RS-03-064

June 27, 2003

U. S. Nuclear Regulatory Commission
Attn: Document Control Desk
Washington, DC 20555-0001Braidwood Station, Units 1 and 2
Facility Operating License Nos. NPF-72 and NPF-77
NRC Docket Nos. STN 50-456 and STN 50-457Byron Station, Units 1 and 2
Facility Operating License Nos. NPF-37 and NPF-66
NRC Docket Nos. STN 50-454 and STN 50-455

Subject: Request for a License Amendment to Revise the Pressurizer Safety Valves Lift Settings

Figure 1

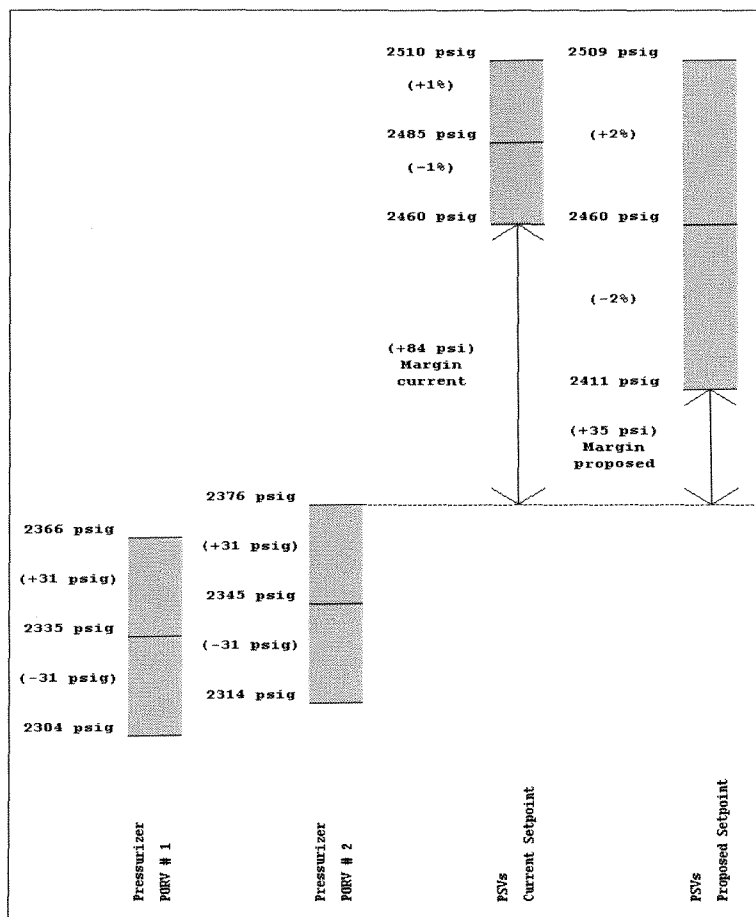
challenges to the PSVs. The impact of the proposed change on the adequacy of margin between the opening of the pressurizer PORVs and the opening of the PSVs was evaluated. The pressurizer PORVs are designed to lift prior to the PSVs. At Braidwood, the two pressurizer PORVs have staggered setpoints of 2335 psig and 2345 psig. The calculated uncertainty associated with opening the pressurizer PORVs was determined to be ± 31 psig based on a recent design change that removed the compensated pressure signal from one of the pressurizer PORVs. That is, currently at Braidwood, both pressurizer PORVs receive input from uncompensated pressure signals. Conservatively applying the pressurizer PORV instrument uncertainty (i.e., ± 31 psig) to the nominal actuation setpoint of the pressurizer PORV with the highest setpoint (i.e., 2345 psig), results in an actuation band between 2314 and 2376 psig. When compared to the current PSV lift setpoint and associated setpoint tolerance (i.e., 2485 psig $\pm 1\%$ resulting in an actuation band of 2460 and 2510 psig), the margin between the highest possible actuation of a pressurizer PORV (i.e., 2376 psig) and the lowest possible actuation of a PSV (i.e. 2460 psig) is 84 psi. When compared to the proposed PSV lift setpoint and associated setpoint tolerance (i.e., 2460 psig $\pm 2\%$ resulting in an actuation band of 2411 and 2509 psig), the margin between the highest possible actuation of a pressurizer PORV (i.e., 2376 psig) and the lowest possible actuation of a PSV (i.e. 2411 psig) is 35 psi. Refer to Figure 1 below.

Although the proposed change results in a reduction in the margin between opening the pressurizer PORVs and opening the PSVs, the resulting margin is still sufficient to ensure that the PORVs will actuate prior to the PSVs.
